**IN THE MATTER** of Proposed Plan Change 5 to the Operative Hamilton  
City District Plan

**STATEMENT OF EVIDENCE OF ALASTAIR JAMES BLACK  
(TRANSPORT)**

**Dated 2 September 2022**

**Plan Change 5 Peacocke  
Review of Transport Submissions**

**Figure 2: Extract from Minor Arterial Design for Peacocke Road**

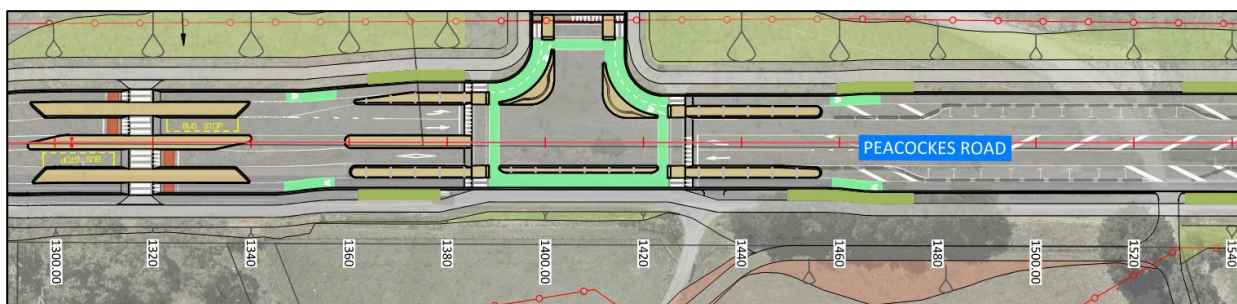
The Adare Company (53.21 and 56.98(5)) submitted seeking that transport corridor criteria for a Peacocke specific residential minor arterial be included.

As illustrated in the figure below, much of the minor arterial network is currently being designed and constructed by HCC. The only section not being actively considered by HCC is the minor arterial south of the Local Centre. Specific design of matters like stormwater and topographical constraints will inform detailed design of the corridor at the time of subdivision.

I support the submissions seeking that a Peacocke specific minor arterial corridor is included as there is sufficient design information to specify the preferred cross-section for the remaining length of minor arterial.

I recommend that Table 15-5b is amended to reflect the current design cross-section of Peacocke Road. Refer to Appendix 1 for the detail of this cross-section.

**Figure 6: Revised Indicative Local Road to Ohaupo Road**

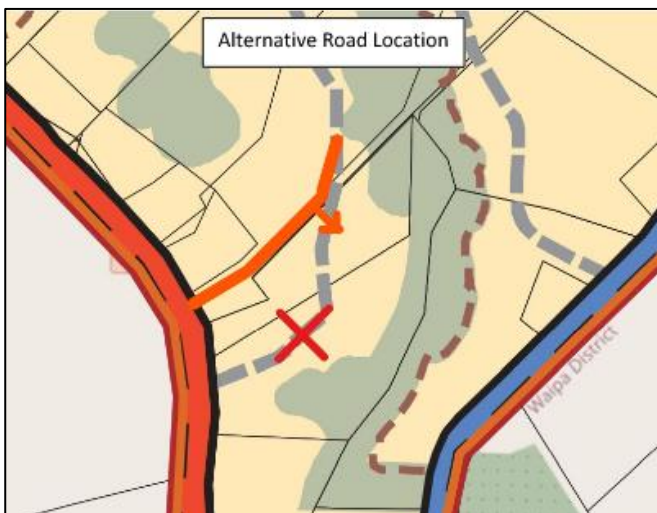
Submission 12.2 (Hodgson Trustee Management Co. Limited) and Submission 50.29 (Stuart and Maylene Ross) both sought changes to the location of the indicative local road connecting to Ohaupo Road. The alternative location shown below (extract from Submission 50.29) is supported because:

- = The revised location maximises sight distance in both directions from the proposed local road; and
- = The revised location aligns with a previous subdivision (HCC Ref: 11.2014.5972) that provided an “access at least 20m wide for future roading if needed”.

**Figure 7: Relocation of Indicative Local Road**

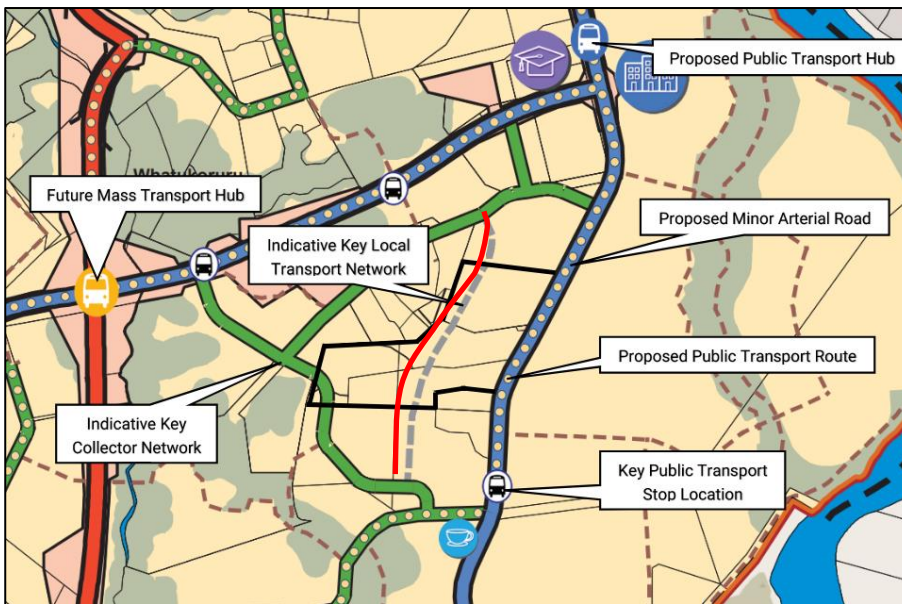
The indicative nature of the alignments is already described in the structure plan at Chapter 3A, Development Area 1: Peacocke Structure Plan, Peacocke Transportation network (page 18-19).

There may be topographical or ecological constraints that make this proposed change unacceptable.

**Figure 8: Submission 44.3, Approximate Extent of Subject Property**

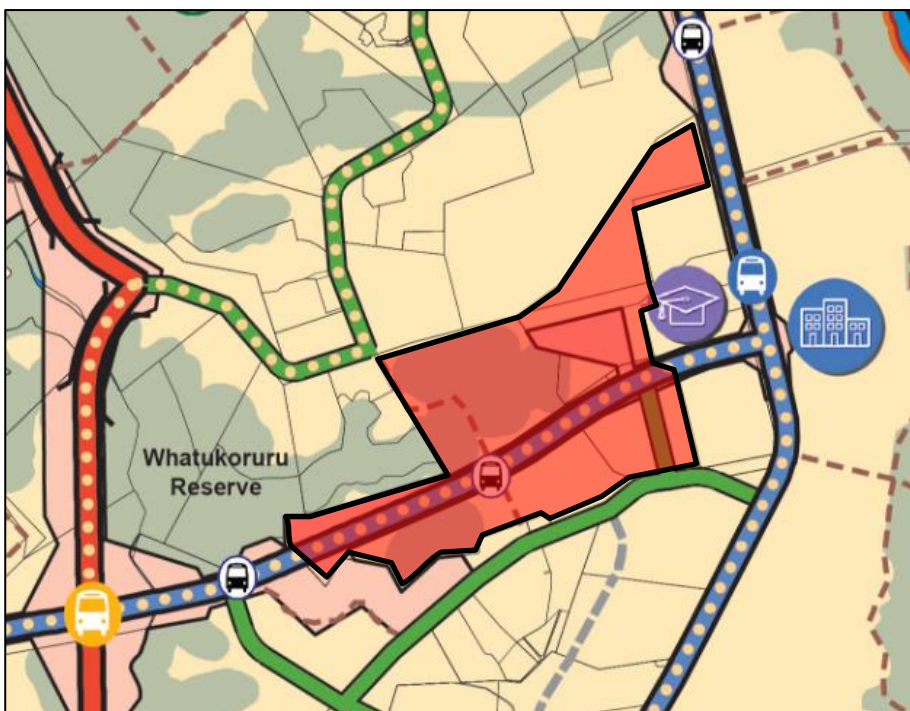
The submission seeks removal of the proposed collector road from their property or amendments to clarify that the transport network is indicative only and is not intended to show exact alignments. I understand that this submission relates to the properties shaded red in the figure below.

In my view it is important that the Structure Plan clearly identifies connected and integrated collector network, including a connection to the minor arterial. I do not support complete removal of the collector road.

**Figure 9: New Indicative Local Road to Peacocke Road**

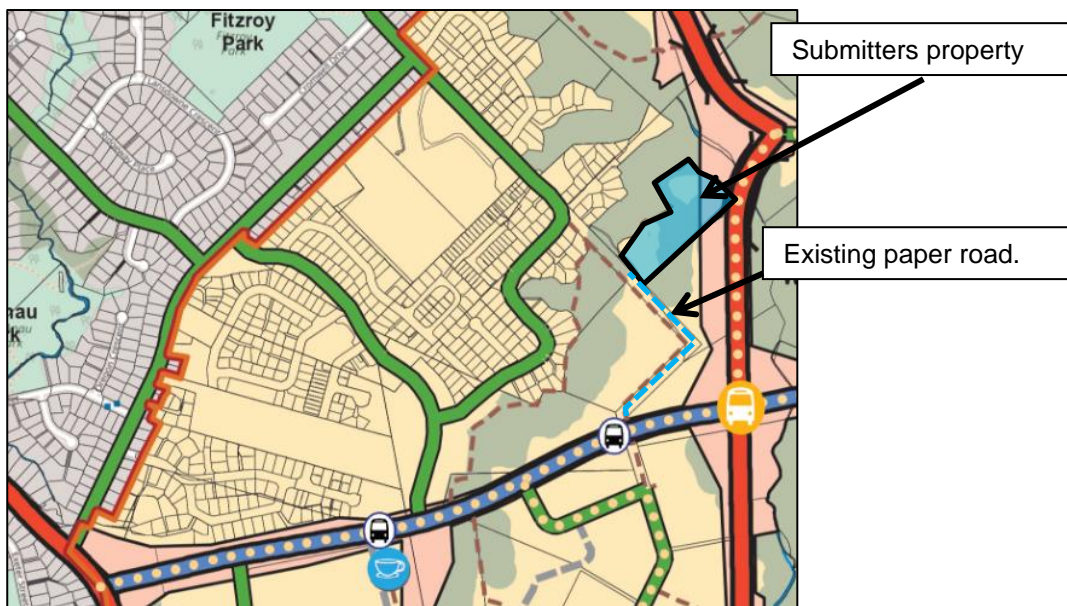
I recommend that the Adare submission seeking a new indicative local road be included on the structure plan map is accepted. The proposed local road will connect to Peacocke Road midway between two signalised intersections and gives certainty that access between the affected land and Peacocke Road (a minor arterial) is anticipated.

**Figure 11: Revised Bus Stop Locations**

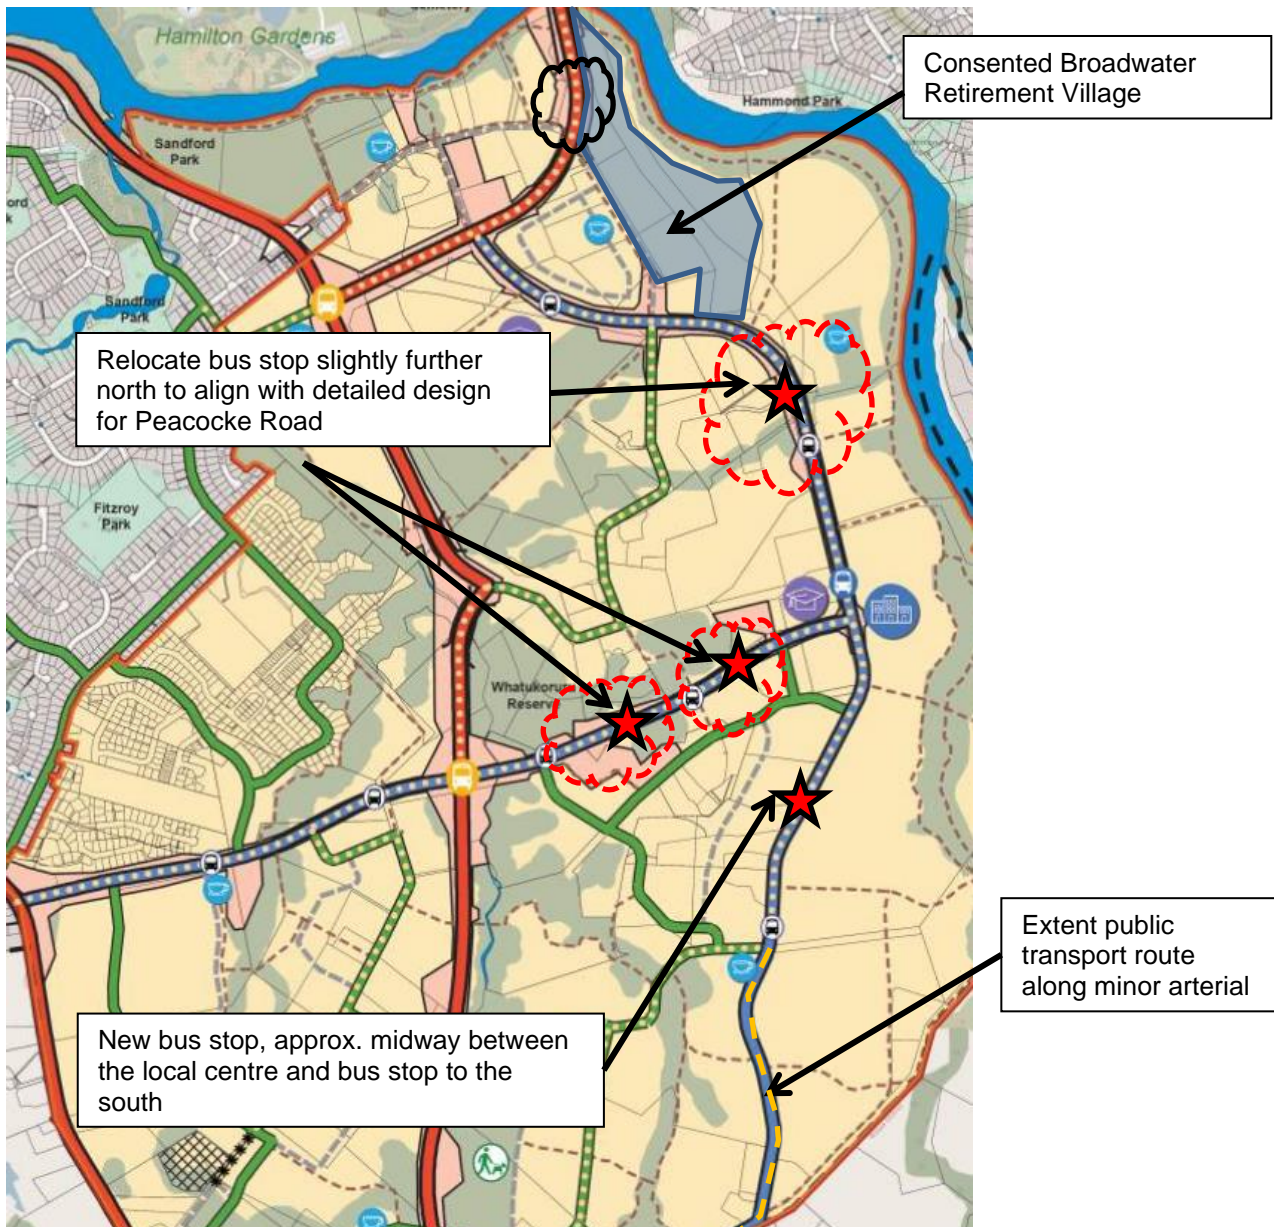
WRC (36.75) seeks that additional bus stops are shown on Figure 2-2 Peacocke Structure Plan – Transport Network.

WRC seek an additional bus stop be included on the major arterial leading to the new Waikato River Bridge (indicated by the black cloud on the figure below). Much of the potential catchment east of the major arterial has been consented as a retirement village (including a dementia and hospital unit) or has access to the stop on Peacocke Road. The catchment west of the minor arterial is limited with land uses including open space and the HCC water treatment plant. This section of the major arterial is under construction and safe pedestrian access to/from the stop would likely require an underpass to be constructed. I do not support including a bus stop in this location.

The bus stops shown on Figure 2-2 Peacocke Structure Plan – Transport Network do not accurately reflect the locations determined through detailed design of Peacocke Road and the changes to the figure are necessary. The proposed bus stop locations should be as indicated below.
